## MURR SUBDIVISION

PCD File No.: MS231

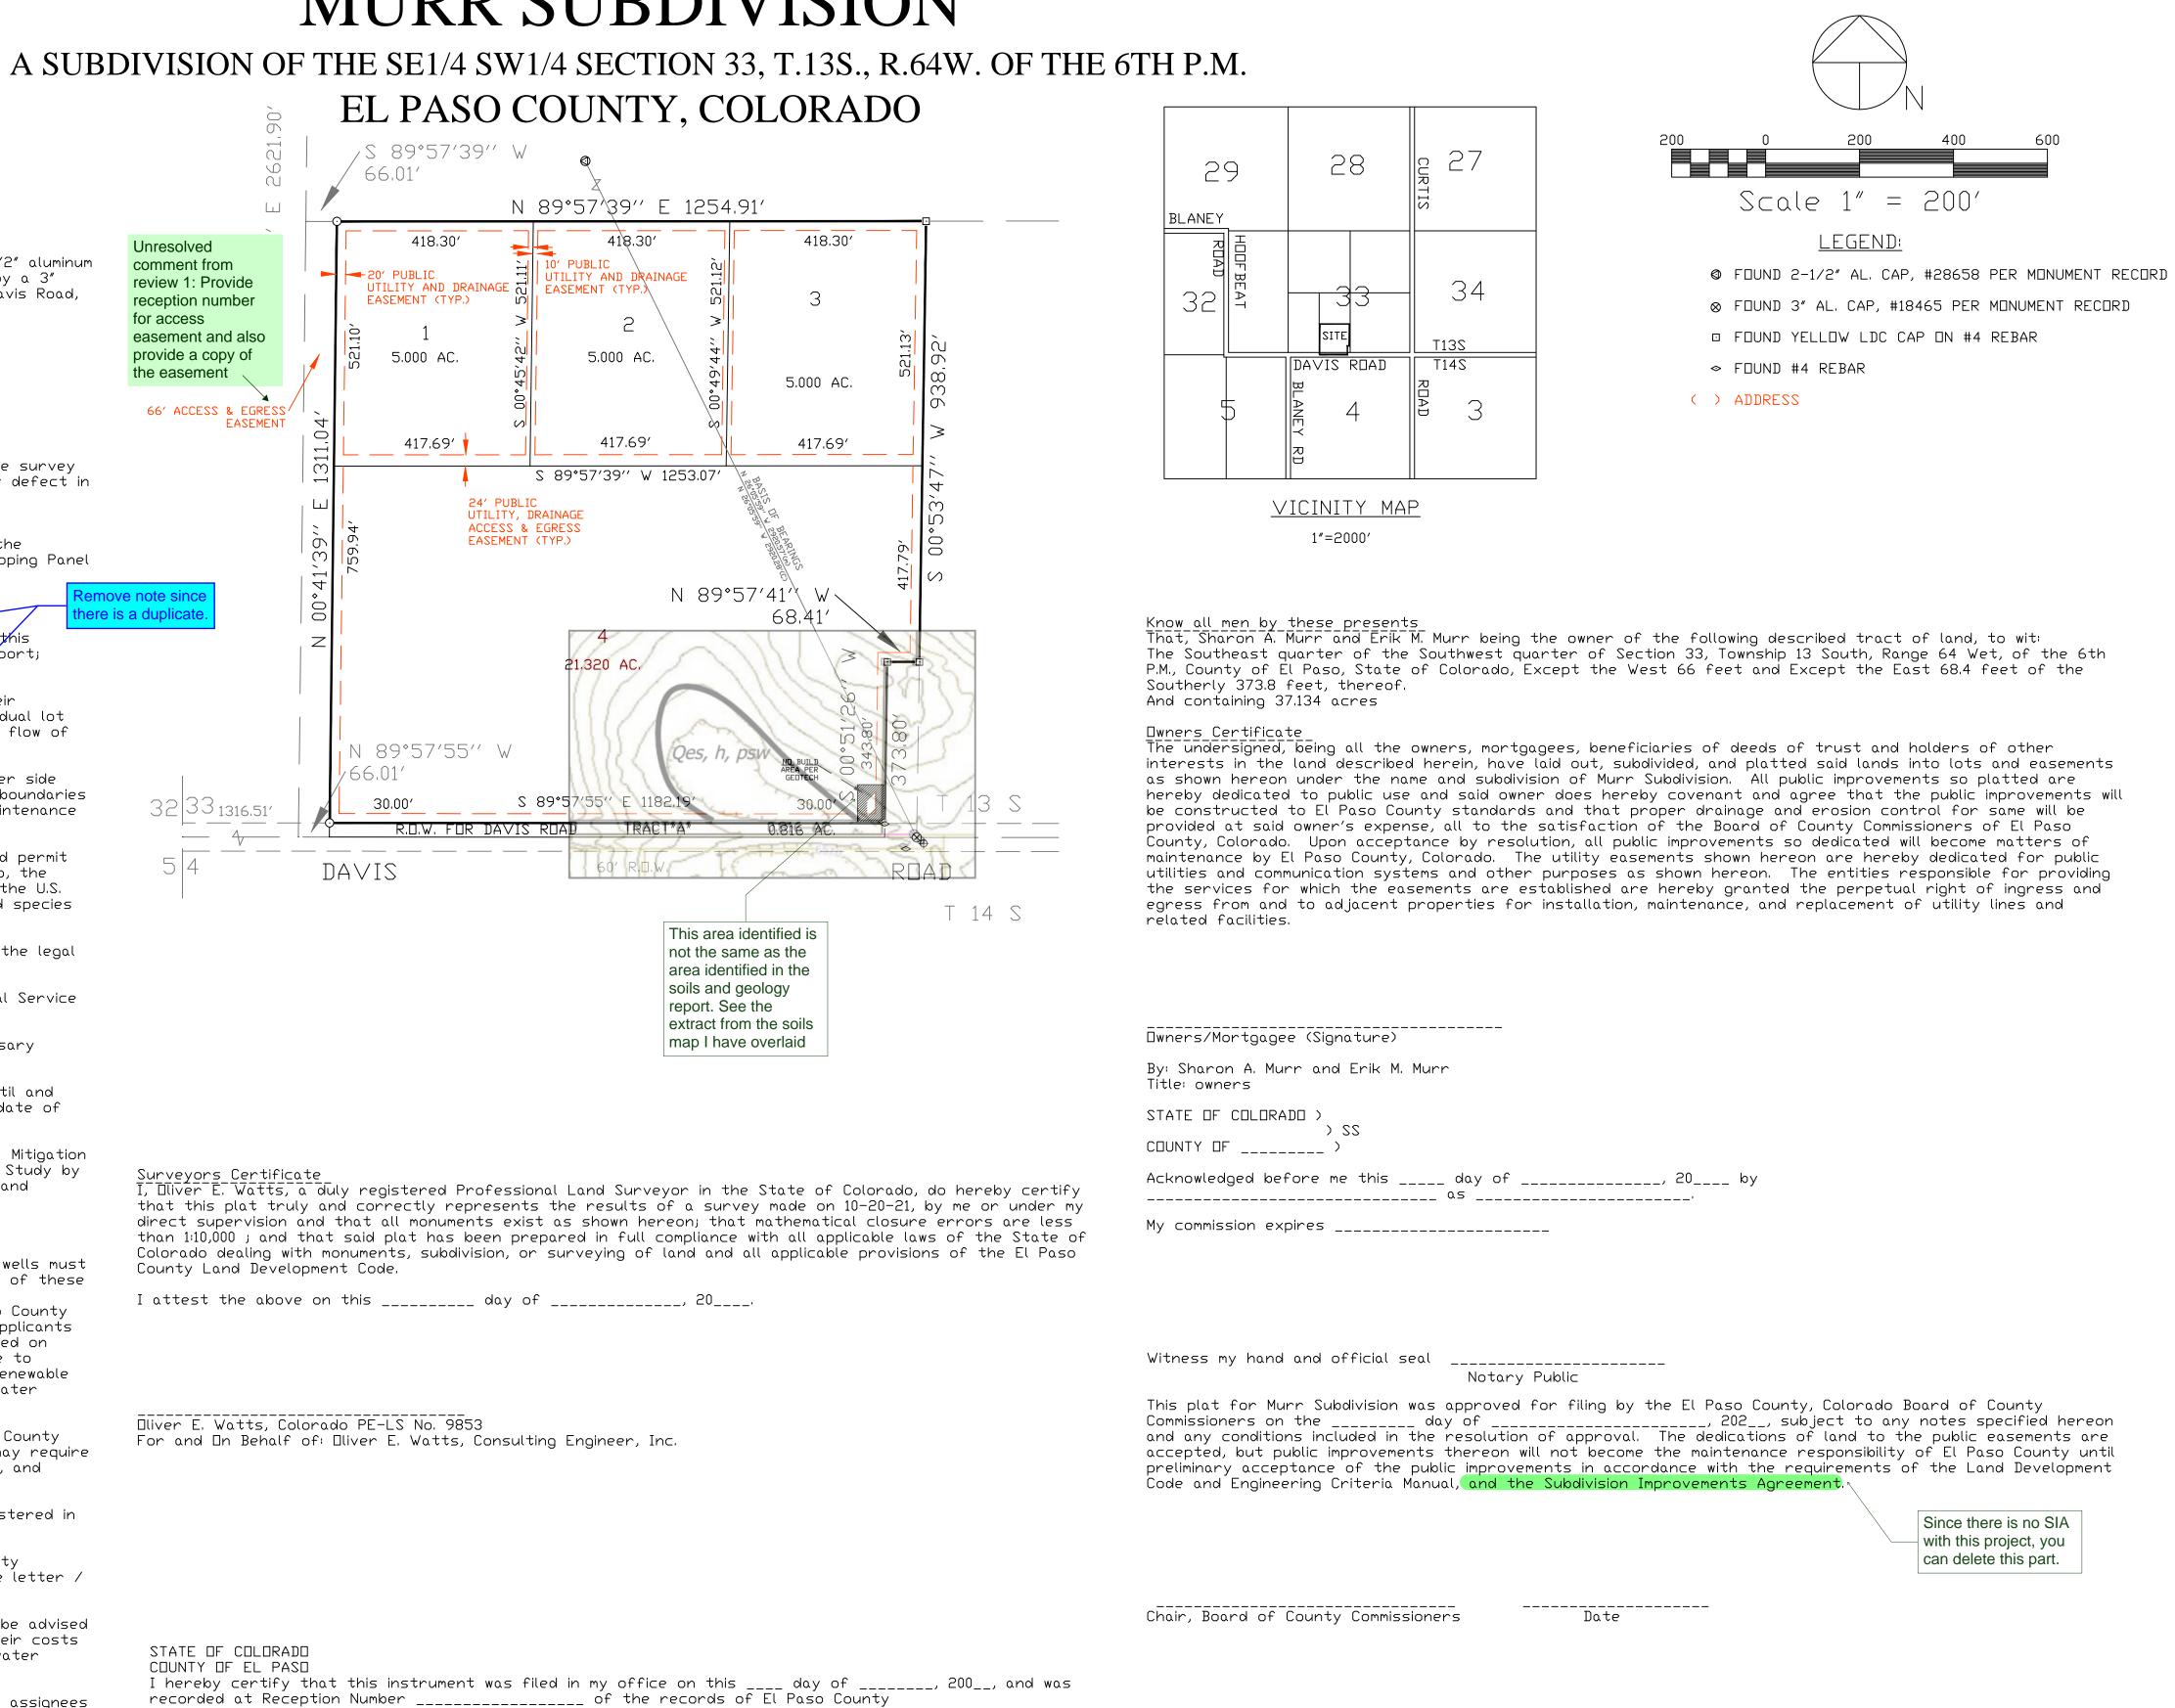
Hydro Compaction: Unresolved comment from review 1: Hydro compaction on which lots?

## resolved from review 1. Add notes to plat.
